**CITY OF BLOOMINGTON
PLAN COMMISSION
June 15, 2015 @ 5:30 p.m.**

**BLOOMINGTON PLAN COMMISSION
STAFF REPORT
Location: 2110 E. Covenant Dr.**

**CASE #: UV-12-15
DATE: June 15, 2015**

**BLOOMINGTON PLAN COMMISSION
STAFF REPORT
Location: 631 N. College Avenue**

UV-12-15
Site Plan

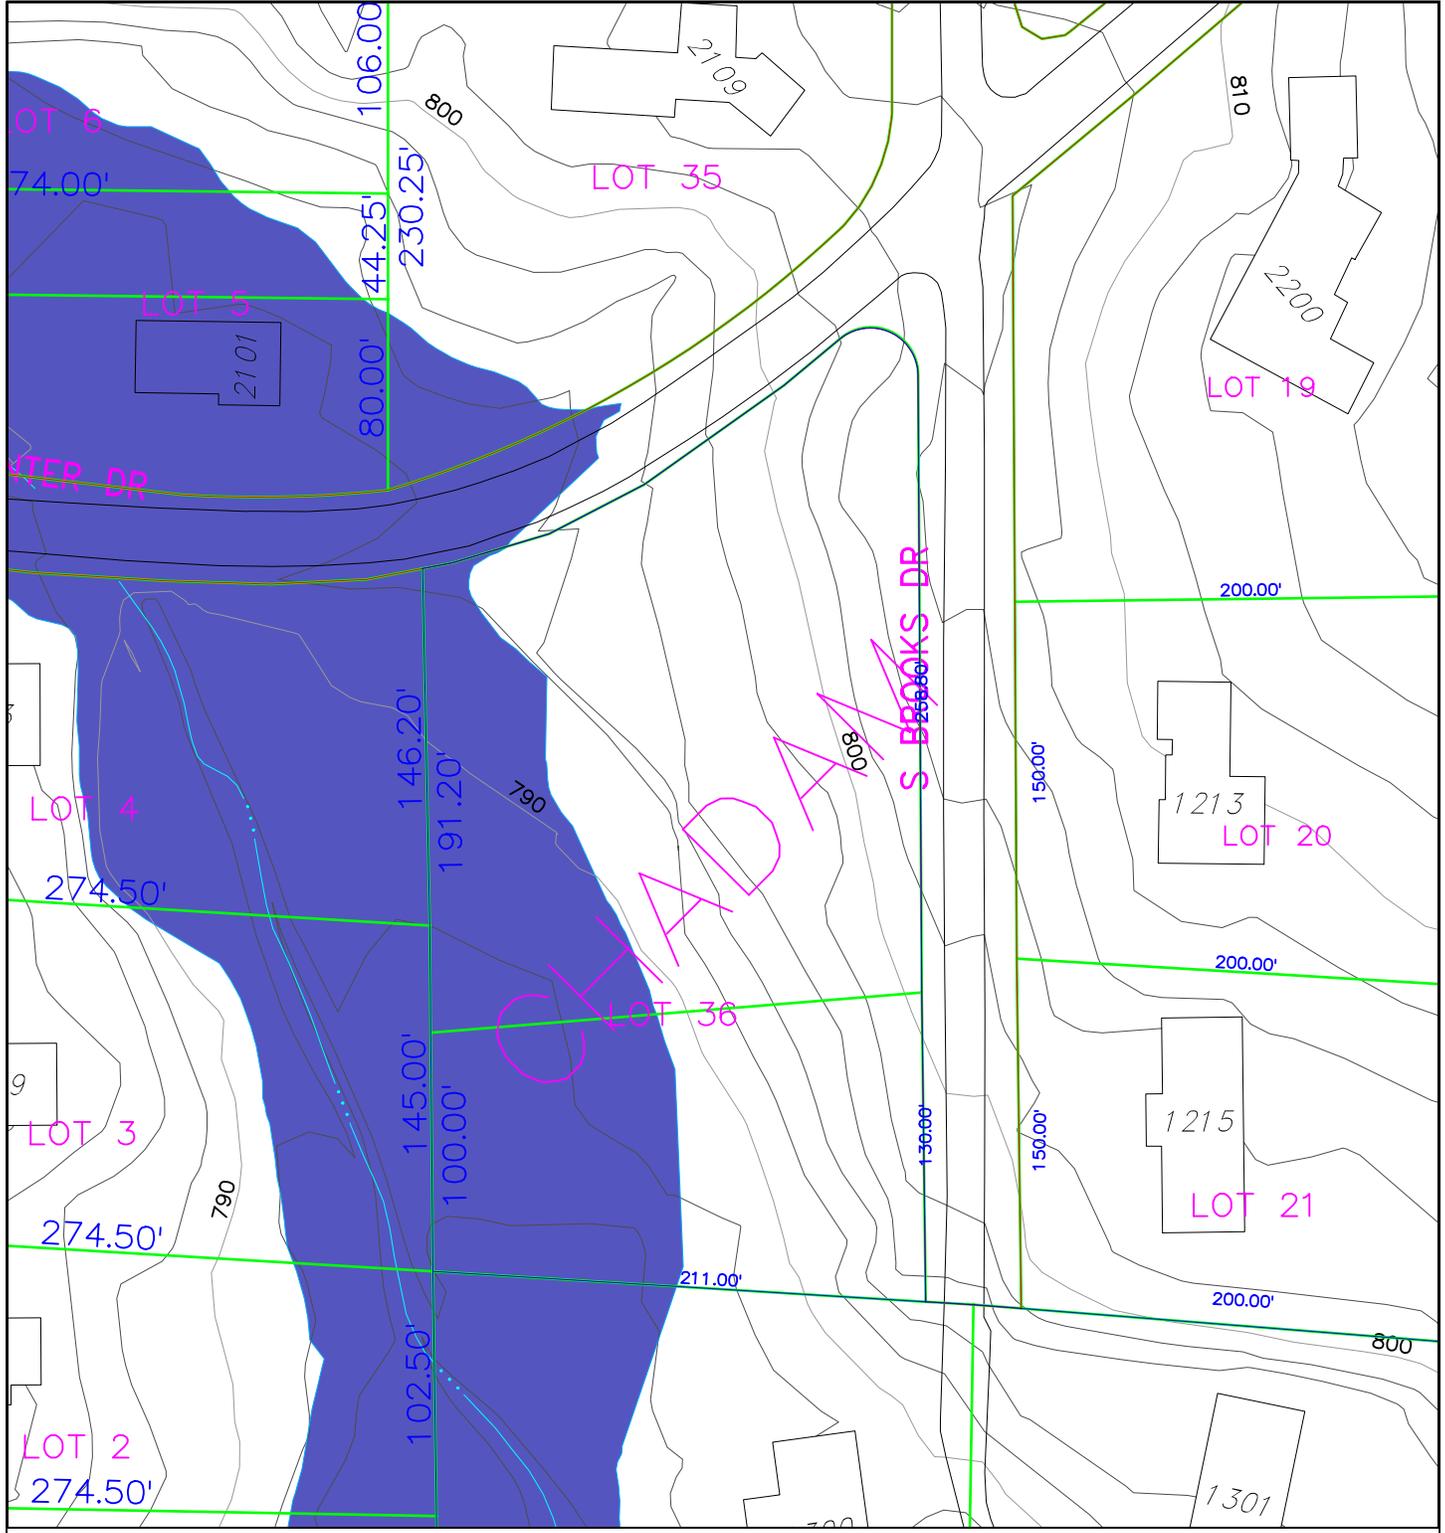
As stated, the petitioners are constructing a new single family house on this lot. The previous home on the lot utilized a driveway and driveway cut that is within the floodway by about 20 feet. The petitioners wish to utilize this existing cut and construct a new "circle drive" on the north side of the house along Covenant. Approximately 65 feet, or 650 square feet, of the drive is within the floodway. Of the 650 square feet, approximately 400 square feet is in the same location as the previous driveway.

The petitioners are requesting a use variance to allow for construction of this driveway in the floodway. The drive location was not within the mapped floodway prior to 2012. No fill material would be placed in the floodway. The portions of the drive within the floodway would be constructed of permeable pavers to reduce the potential impact of leaking oil and gasoline. The driveway is more than 100 feet from the actual creek. The Indiana Department of Natural Resources has already approved a "construction in a floodway" permit for this project. While there is no delineated floodway fringe for this section of the west branch of Jackson Creek, staff believes that if it were delineated it is highly likely that the proposed drive location would be located within the floodway fringe. The UDO permits drive and parking areas in the floodway fringe if constructed of permeable materials. In addition, reuse of the existing drive cut would allow for the preservation of two existing trees.

1.) The proposed driveway in question is proposed to stretch between about 50 to 70 feet through the edge of the floodplain. The variation in distance is due to the arched shape of the drive. The EC believes that because this drive is proposed to be at the outside edge of the floodplain, and that the petitioner is proposing to use permeable pavers, there is no significant safety risk to downstream flooding or contamination to the watershed if cautionary best management practices are used.

The EC further believes that a recordable commitment should be made to ensure approved pavers are installed correctly and will remain permeable in perpetuity by all owners. The EC recommends that the Petitioner decide on a brand and style of paver for approval by the Planning and Transportation Department (P&TD), and contact the P&TD in advance of the installation so staff can observe installation.

- 1.) The Petitioner should commit to the P&TD approval of the brand and style of pavers, contact the department prior to installation, and allow staff to inspect installation, prior to a use variance that allows construction in a floodway.

STAFF RESPONSE: Staff will consider this as a possible condition for the BZA review and approval.

SCHEMATIC ELEVATIONS

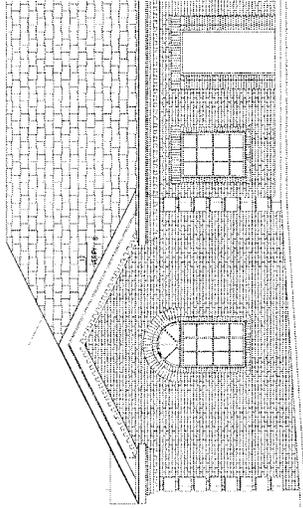
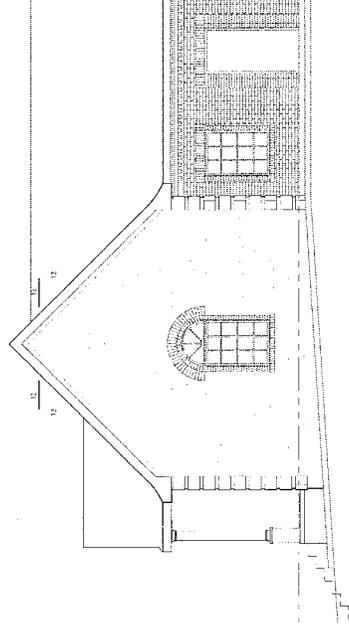
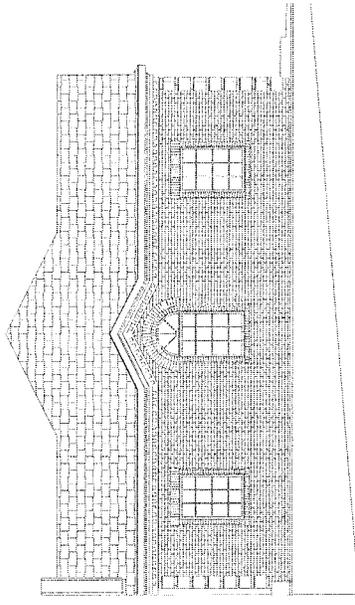
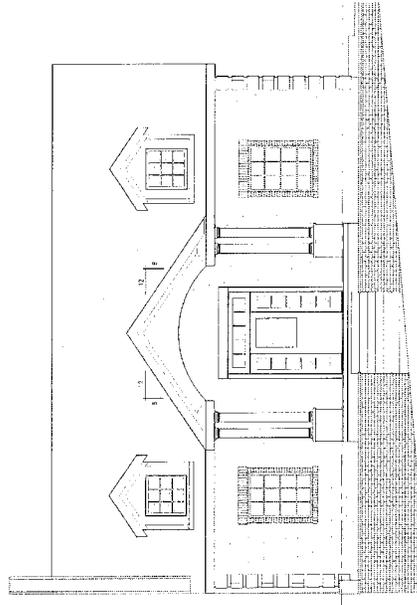
Alignment: The existing building is set back 15 feet from the street right-of-way; with the proposed porch, the building will be set back 10 feet from the street right-of-way. The historic buildings to the north and south are approximately 15 feet and 19 feet, respectively, from the street right-of-way. The DGO permits setbacks of as much as 15 feet, however the DGO also requires the building to match the setback of the adjacent historic residential buildings to the north and south. The proposal is a reuse of an existing building and the porch is proposed to match the residential character of adjacent properties and provide pedestrian interest.

Building Alignment Waiver-20.03.340(a)(2): The proposed porch addition will have a 10 foot setback from the street right-of-way, while the UDO requires that the building align with the adjacent historic structures, which are set back 15 and 19 feet from the street right-of-way. The existing structure does currently align with the historic property to the north. This is a reuse of an existing building, and

RECOMMENDATION: Staff recommends approval of SP-13-15 with the following conditions:

1. A minimum of 4 bike parking spaces must be placed within 50' of the entrance to the building.
2. Petitioner must reduce parking to 8 spaces before final in order to meet maximum parking, access, and parking setback standards.
3. Petitioner will submit an updated site plan reflecting above conditions and adjusting the landscaping as needed to meet all requirements before the issuance of a building permit.
